Chapter 3

APPENDIX C – TRIBAL AGENCY POSITION SUPPORTING MATERIALS

Appendix C contains Tribal Cooperating Agencies' comments and supporting documentation that represent major differences of opinion with the analyses as presented in the SDEIS. The information was submitted by the Bois Forte, Grand Portage, Fond du Lac, Great Lakes Indian Fish & Wildlife Commission, and the 1854 Treaty Authority. All materials in this appendix are Tribal views provided verbatim and have not been validated or approved by the Co-lead Agencies.

Figure F-01-10.1

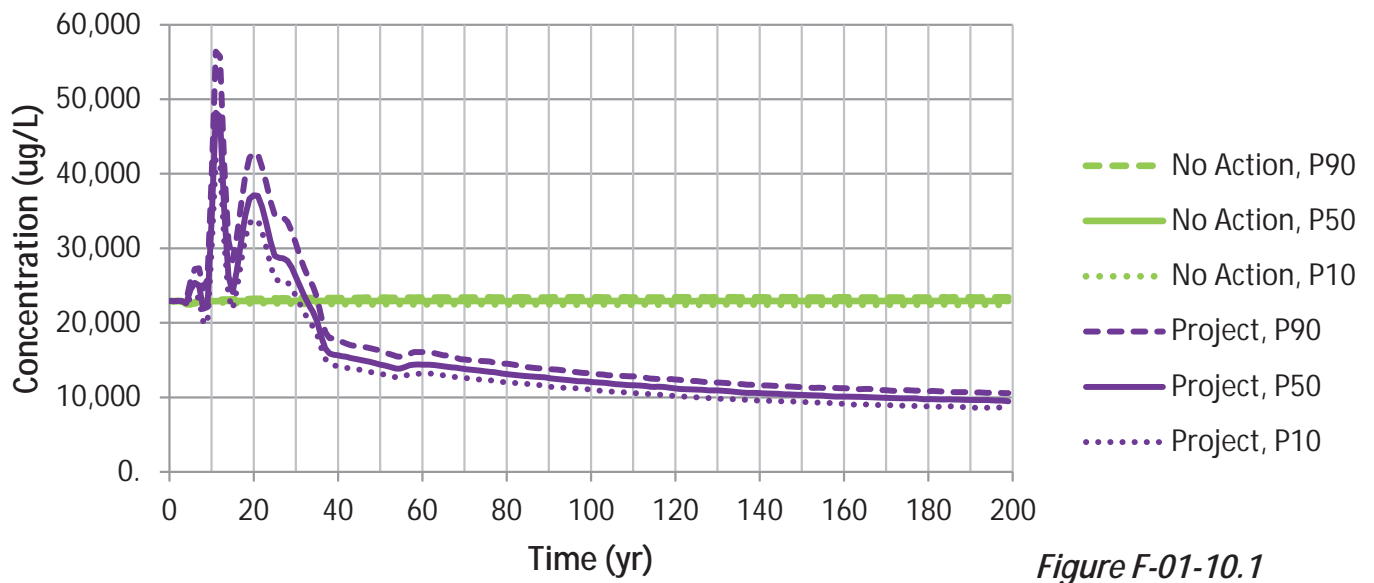
Observed mean existing conditions at the tailings basin toe vs. annual maximum existing conditions predicted by Goldsim. (Goldsim predicted mean concentrations are not provided in Modeling Data Package Vol 2-Plant Site v9 MAR2013)

The above examples are not an exhaustive list of discrepancies between observed existing water quality data and the Goldsim P50 prediction of the No-Action alternative (continuation of existing conditions) but highlight some of the most notable discrepancies. What the discrepancies demonstrate is that the Goldsim model is a relatively poor predictor of current conditions. If a model is unable to accurately predict current conditions it is even less likely to accurately predict future Project conditions. The Goldsim models need to be better calibrated to existing conditions (the calibration effort reported in "Calibration of the Existing Natural Watershed at the Plant Site v4 MAR2012" only compared model output to upstream site PM-12 and apparently did a poor job of preparing the models to predict either the lower reaches of the Embarrass or the Partridge River.) and model results recalculated.

Plant Site Version 5.0 Model
Annual Maximum of Concentration Statistics
CI at the North Toe

Fig 4. 303d Impaired Waters Surrounding the Proposed Polymet Mine

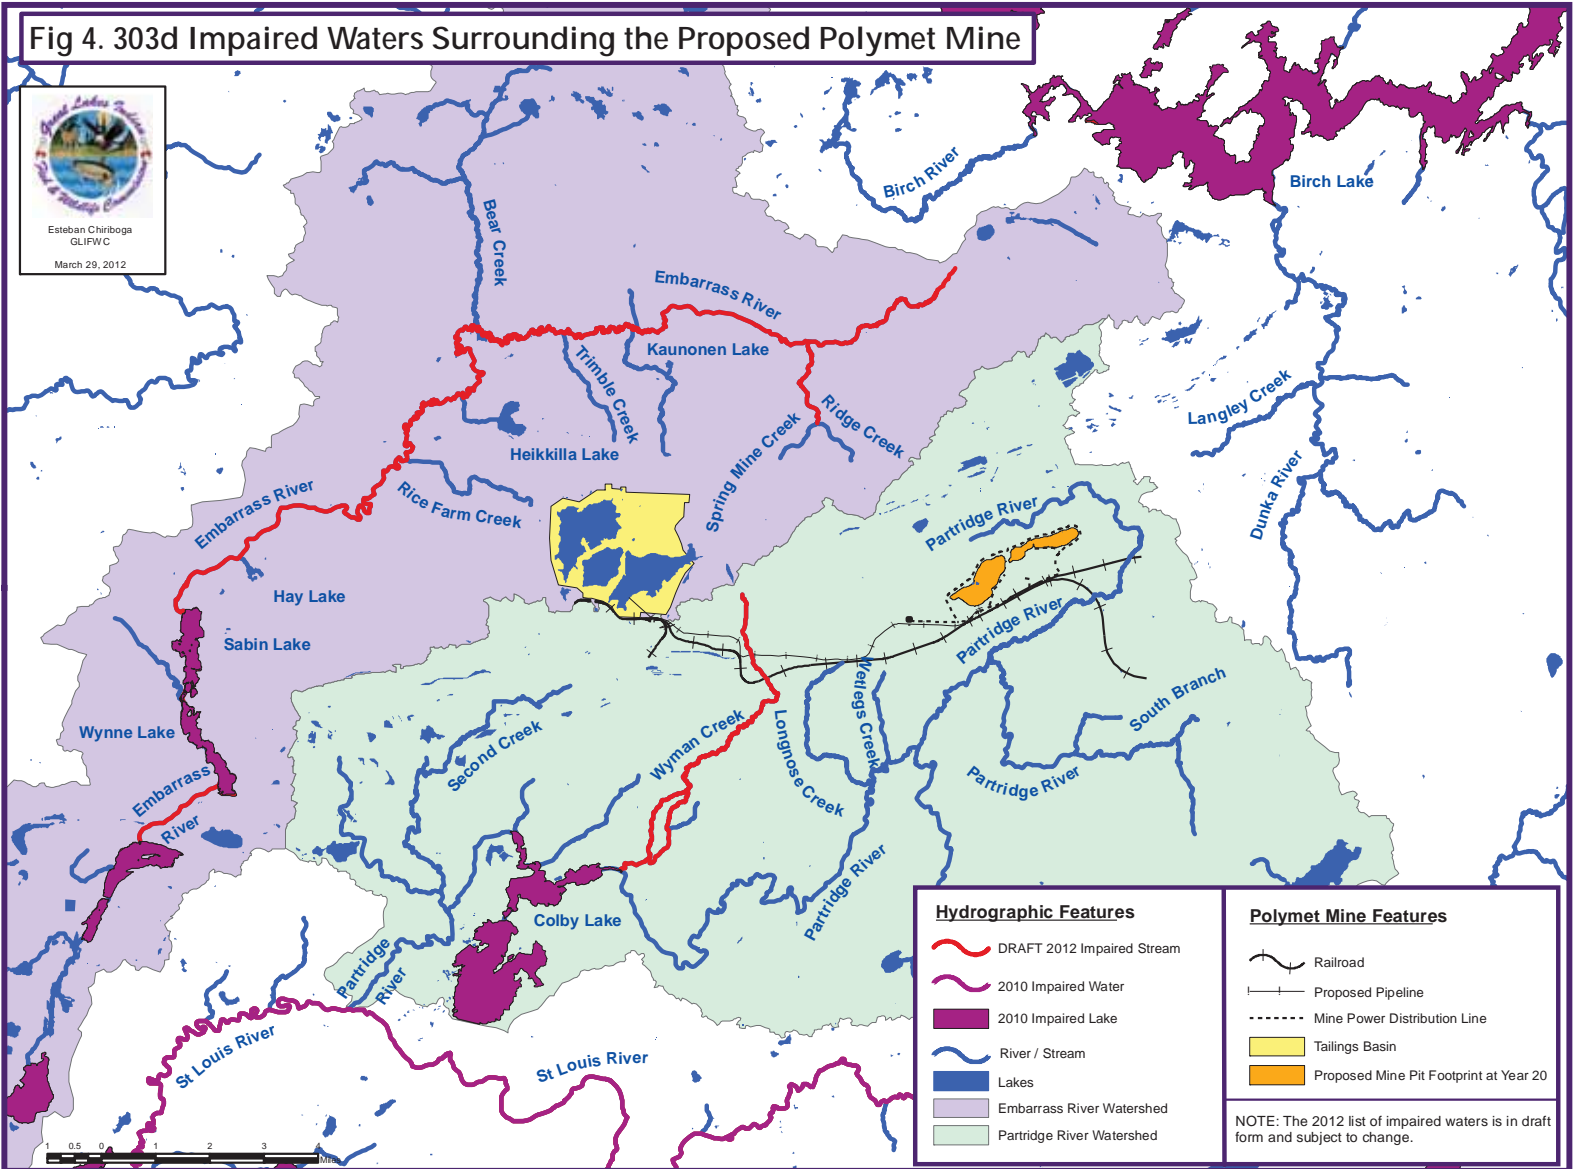
4.2.6 Aquatic Species					
GLIFWC 84	GLIFWC	4.2.6.4 Mercury Concentrations In Fish	The discussion of 303d listing is not correct because the Embarrass River is on the 2012 303d list. See GLIFWC map of 303d waters in the wild rice attachment (figure 3). Sulfate has a link to mercury methylation which is directly related to mercury contamination in fish. This should be noted here.	Text revised to clarify the current status of 303(d) listings. The Embarrass River is on the 303d list as impaired for Fishes Bioassessment, a category not related to mercury.	ok. However it should be noted that the Embarrass river is expected to be impaired for sulfate in the next draft list. Language regarding changes to 303d lists should be added.

Figure 1: Analog Drawdown Contours in Relation to Proposed NorthMet Pits

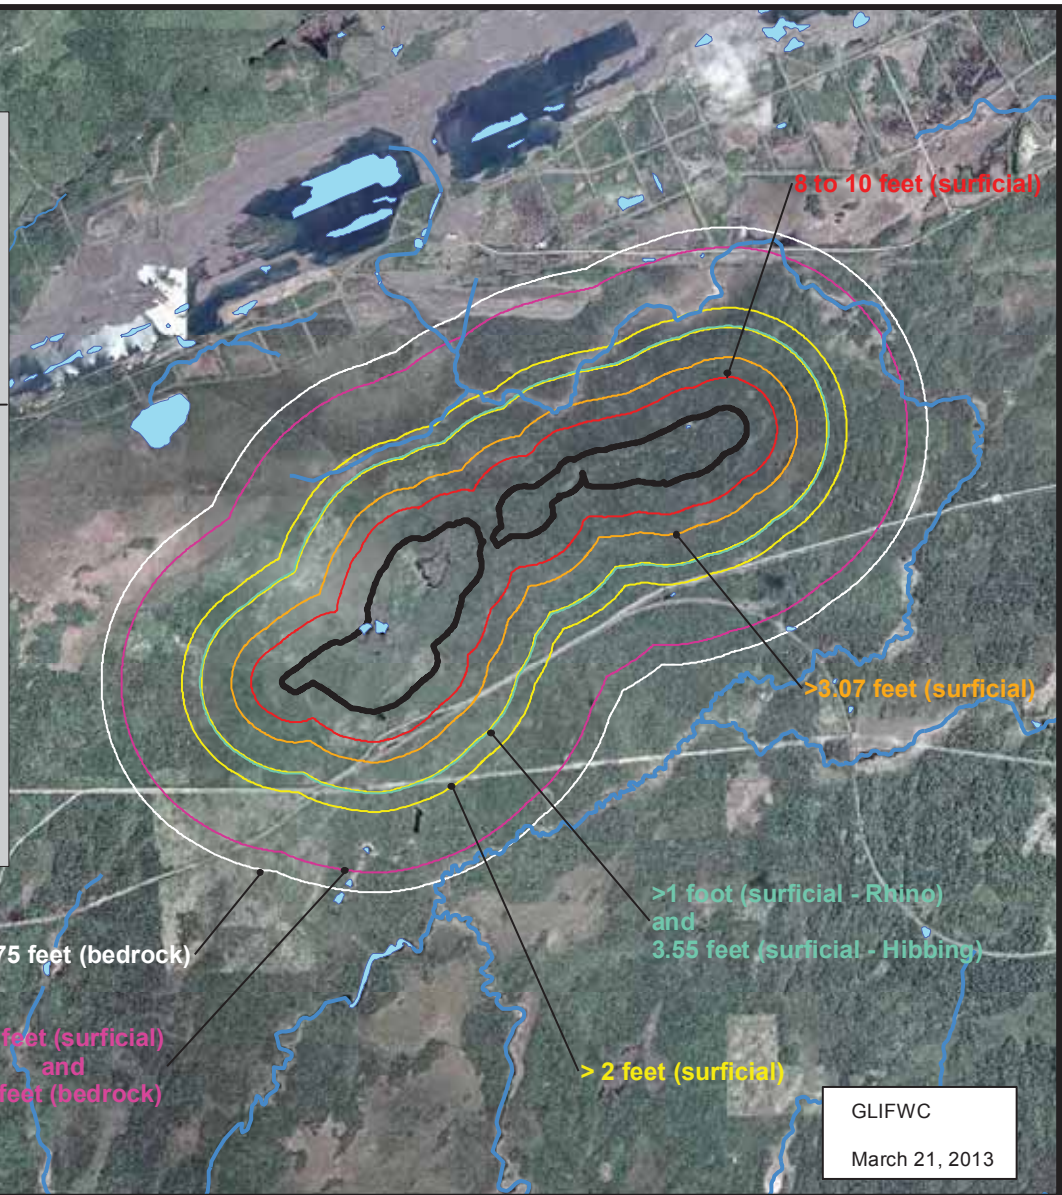
Contour lines showing the analog well information in relation to the proposed NorthMet mine site are provided in Figure 1.

Figure 8: Zone 3 and 4 Wetlands

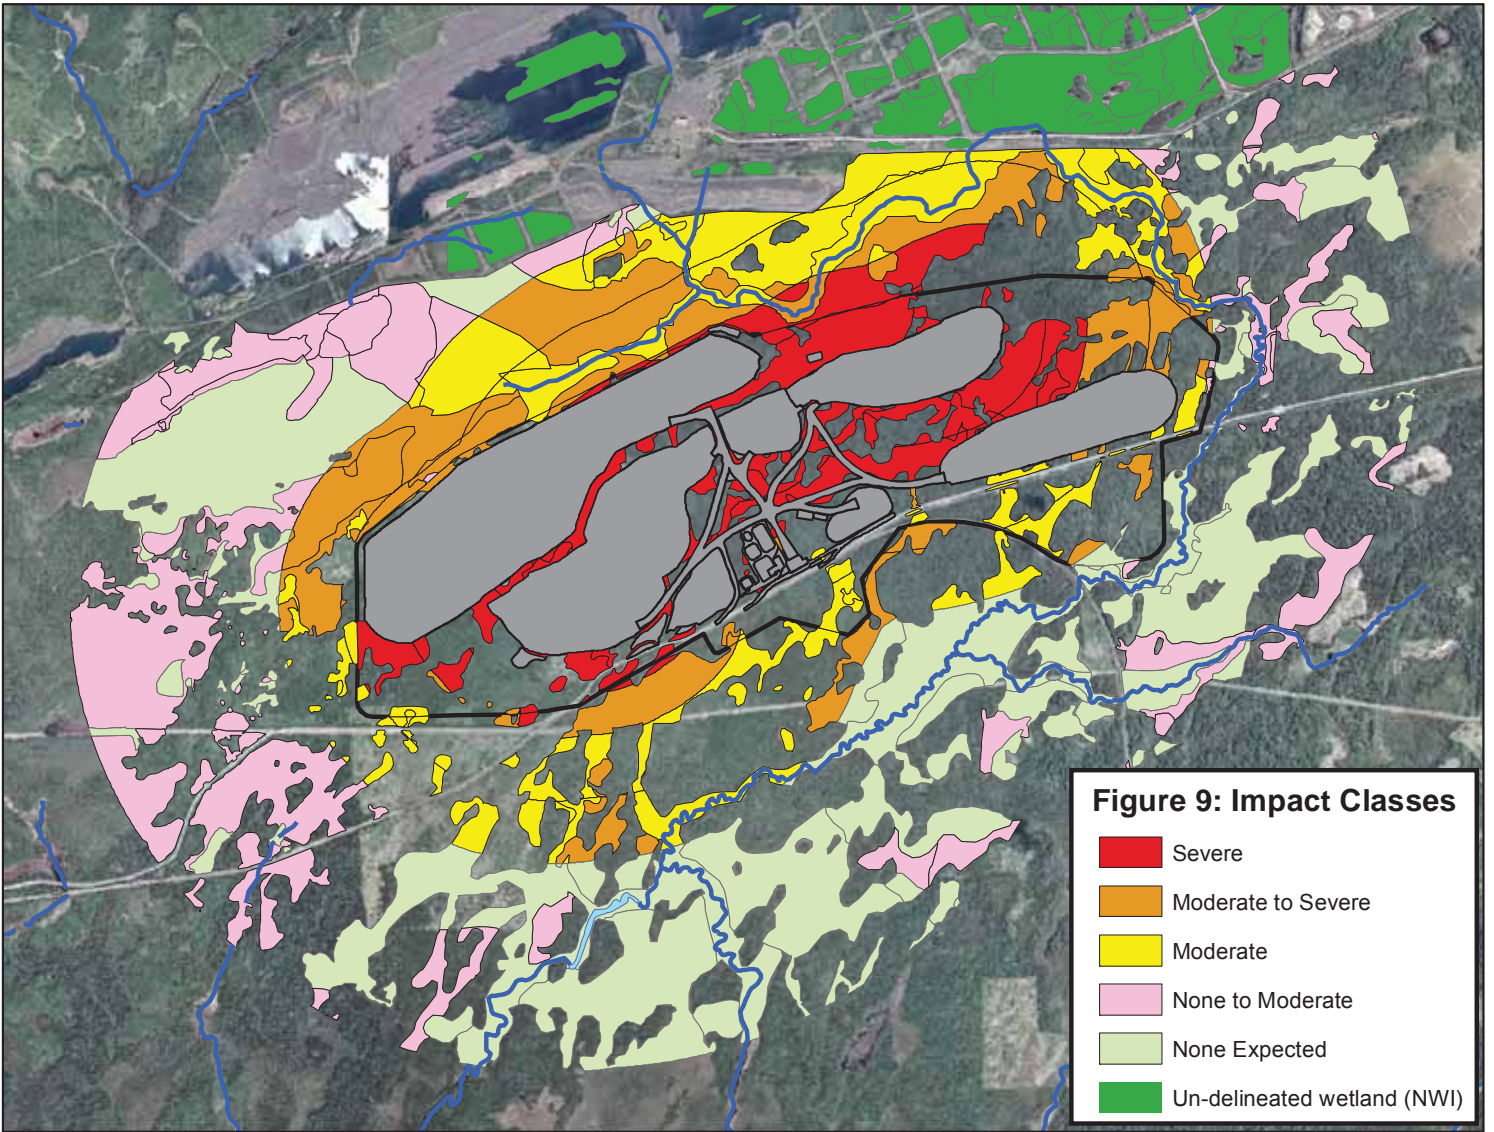
Zone 3 wetlands on the north side of the mine pits are also subject to impacts related to the dewatering of the Northshore pit. Figure 8 illustrates the possible extent of drawdown impacts at the Northshore pit based on the Hibtac well data provided by the MNDNR Mining Hydrologist Michael Crotteau. This cumulative effect is not included in version 7 of the data package or the PSDEIS. This analysis should be conducted.

As discussed above zone 4 wetlands on the north side of the proposed mine pits are also subject to impacts related to the dewatering of the Northshore pit (Figure 8).

Figure 23. Annual Maximum of Concentration Statistics: Chloride at the North Toe.

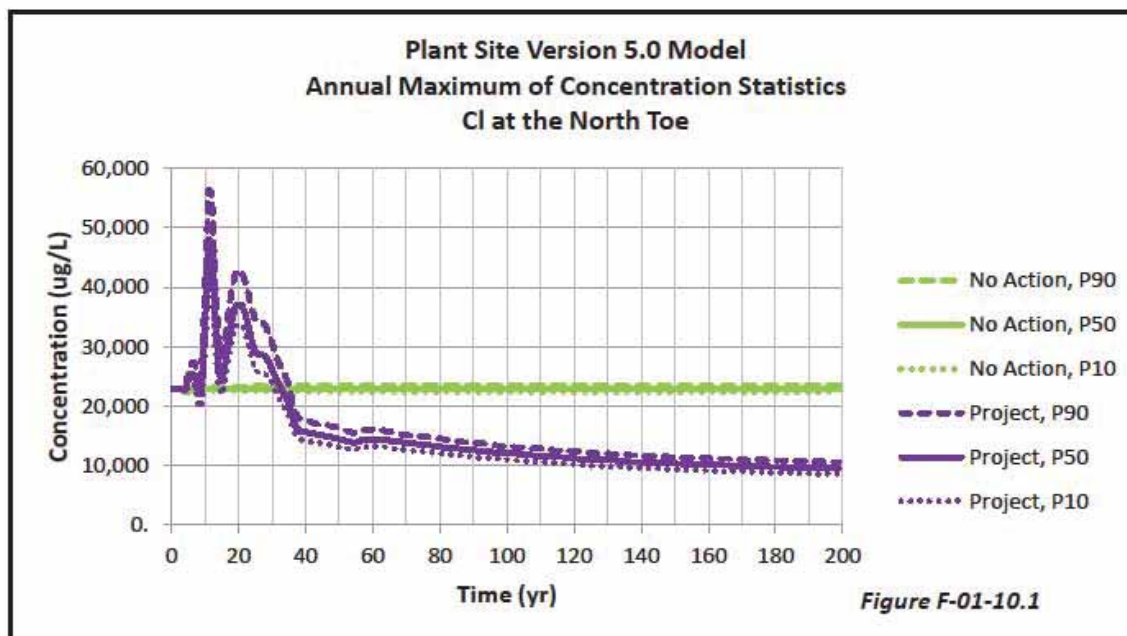
Based on the above CEQ guidelines, it is clear that activities that will occur under the Cliffs Consent Decree should be included in modeling of a No Action alternative. Unfortunately not only are the consent decree activities not included, but the fact that it will be precipitating on the tailings basin for the foreseeable future has not been included in the No Action modeling. This is evident by the model results that show stable levels of chloride coming from the basin for the next 200 years (Figure 23) when there is no ongoing source for chloride. With no source for new chloride, rainwater will gradually dilute the residual chloride in the basin and levels will drop. The PSDEIS claims that the basin's water quality has stabilized and that the current conditions will not change over time. The claim of chemical stability is based on basin pond water sampling for only 4 years (2001 – 2004, PSDEIS Table 4.2.2-23).

Since there has been no water quality data collected in the basin pond for 9 years it is reasonable to assume that the past 9 years of precipitation has diluted the water chemistry in the basin pond, and that eventually the more dilute water will percolate through the basins and be discharged at the toe. If chemical stability is to be assumed, more recent data on basin pool water chemistry is needed. While the CEQ makes it clear that a blind "continuation of existing conditions" model is inappropriate as a No Action alternative, a "continuation of existing conditions" model that ignores simple environmental processes such as precipitation is even less appropriate.
